I maintain a strong objection to application 2020/3525, highlighting further inconveniences arising from the excessive density and overwhelming mass of the development.

In response to the large refuse vehicle in & out document dated 11/10/2023:

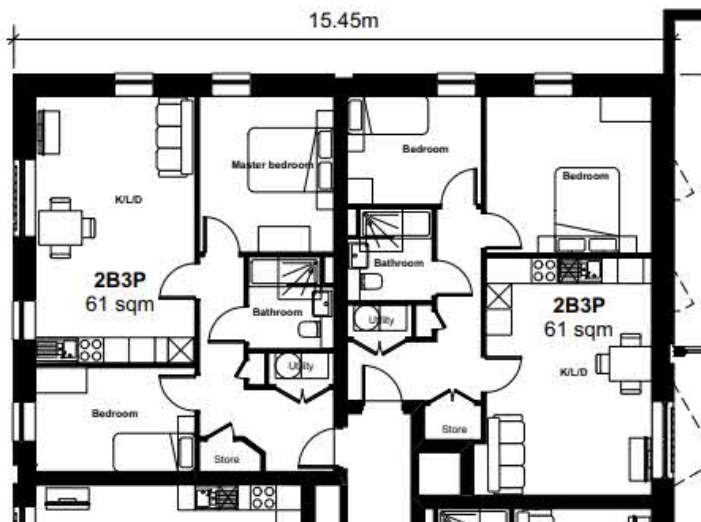
This document further underscores the excessive density of the buildings, resulting in significant challenges for waste management to navigate to the presentation site. Consider the scenario illustrated in the image below, where letters are allocated to key vehicles mentioned in the accompanying notes. Vehicle dimensions have been obtained from the developer's submitted plans:

Vehicle A: In the highly probable scenario where a vehicle is in the loading area, the waste vehicle would be unable to navigate to the presentation area. The probability of this occurrence is especially high considering the lack of parking for visitors, maintenance men, delivery drivers and removal vans. If a single waste collection is missed, it will lead to 8 x 1100L general waste/recycling bins and 5 x 240L food bins being left in the presentation area for an extended period, causing them to overflow and becoming a lure for vermin.

For Vehicles C, D, E, and F: The road's width does not permit Vehicle C and D to overtake Vehicle F (the waste vehicle) when it is exiting the site. This scenario presents a highly probable congestion concern, particularly as the waste vehicle will require a significant amount of time to empty the waste bins while simultaneously obstructing the entrance and exit of the basement car park. This situation would force Vehicles C and D to execute potentially hazardous reversals out of the site, encroaching onto Orchard Lane, where a public footpath commonly used by pedestrians would be obstructed.

Given the duration required for the removal of waste bins, and due to the waste removal truck blocking the entrance to the basement car park, it's reasonable to anticipate that this will lead to significant disruption every week, with queues of vehicles entering the site and exiting the basement.

Vehicle B: The headlights of vehicle B and other parked cars in this parking bay will shine brightly into the windows of two distinct units in Block C's bedrooms disturbing the residents. Please see the floor plans of affect units below:

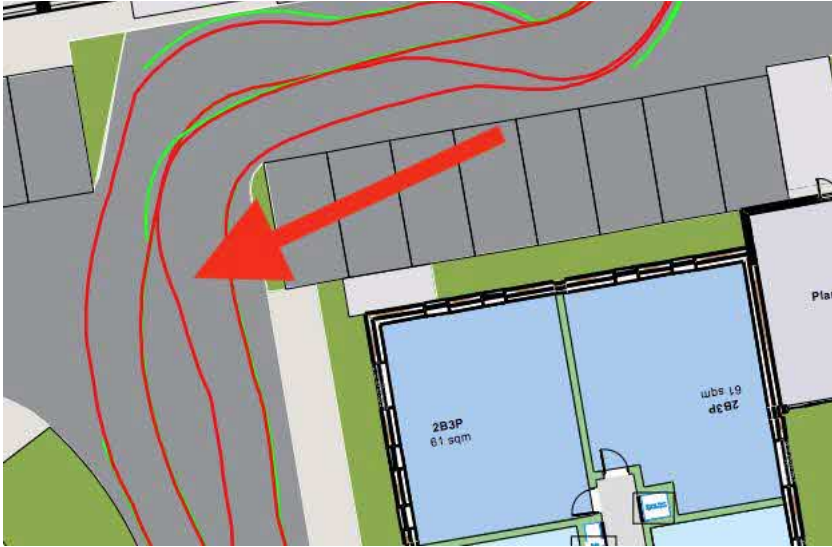
There is still no indication on the plans regarding the placement of the two-way traffic signal for vehicles entering and exiting the basement car park. The diagrams illustrating the sweeping paths of passenger vehicles entering and exiting the basement, as presented in the Transport Statement Addendum Letter, reveal that the road leading to the basement is insufficient in width to permit the safe passage of two cars simultaneously.

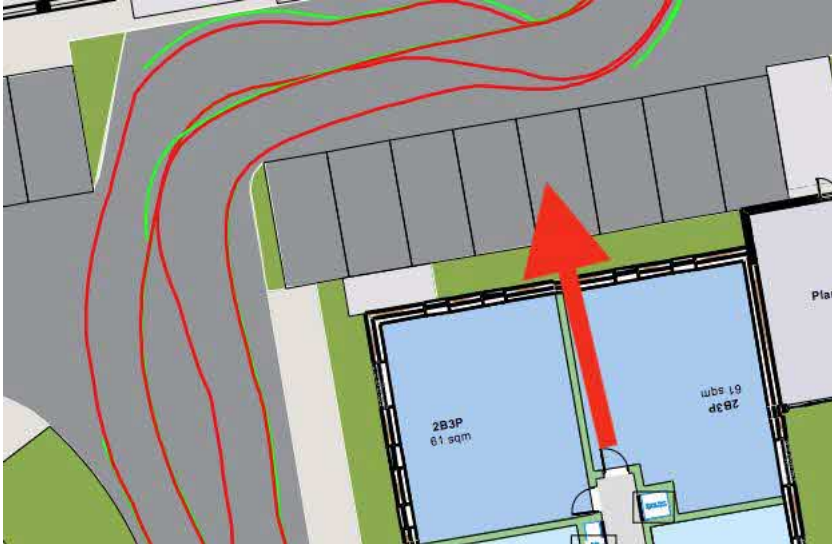
This situation implies that the most sensible location for the placement of the two-way signalling lights would be roughly at this point:

With the signalling placed in this manner, vehicles exiting the parking bays displayed in the below image, will be uncertain whether they are driving into oncoming traffic.

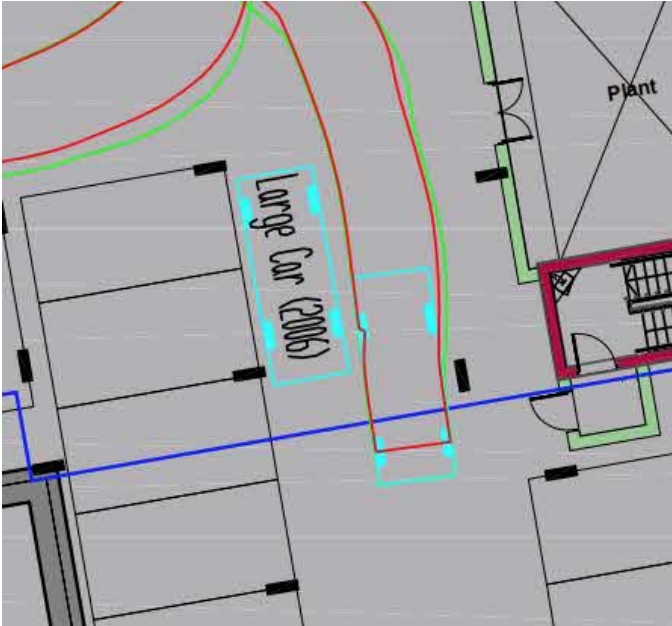
Considering the scenario in which 4 cars are trying to enter the basement car park while 4 cars are attempting to exit:

Vehicles A, B & C: Given that the position of the two-way light signal is unknown, the drivers of Vehicles A, B, and C will not have a clear indication of who has priority to exit via the ramp. The two-way light signal cannot be placed at the base of the ramp as the width of this area is not suitable for two vehicles to pass each other.

Vehicle A: There is a dangerous blind spot on the left-hand side of this car when driving into oncoming traffic.

Vehicles B and G: Vehicle G would need to exercise extreme caution and coordination with Vehicle B to safely pass and reach a parking space in this narrow section, given that it's only wide enough for one vehicle due to a pillar. The manoeuvre is illustrated in the sweeping path of passenger vehicles in the Transport Statement document:

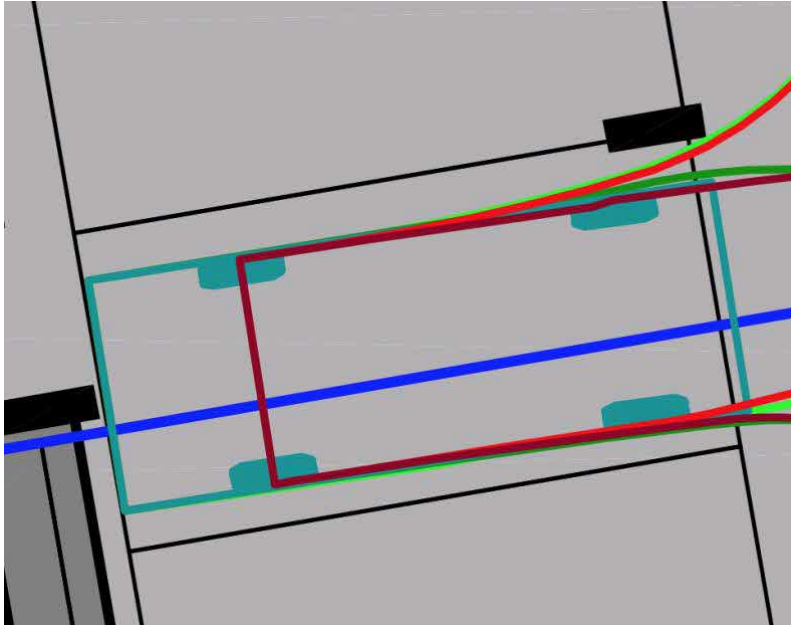
This manoeuvre would not be feasible if a vehicle is parked in either of the two spaces illustrated below, as the vehicles would protrude from the bays due to insufficient size of the parking space.

The Transport Statement document indicates that cars can extend beyond their designated parking spaces, even when parked correctly and as far into their spaces as possible:

Vehicle D: The parking space in which vehicle D is parked should not be classified as a parking space, given that it is significantly obstructed by a pillar.

Vehicles C and F: It would be a tight manoeuvre for vehicle F to pass vehicle C safely upon entry, especially considering potentially protruding vehicles parked in the surrounding bays.

I: It is illustrated under the letter i that a person is having to navigate the basement carpark with a 1100L waste bin, all whilst cars are entering and exiting, to transport the waste bins to the presentation area, which will be incredibly dangerous. This journey will have to be made 26 times a week due to the 8 x 1100L waste bins and 5 x 240L food waste bins.
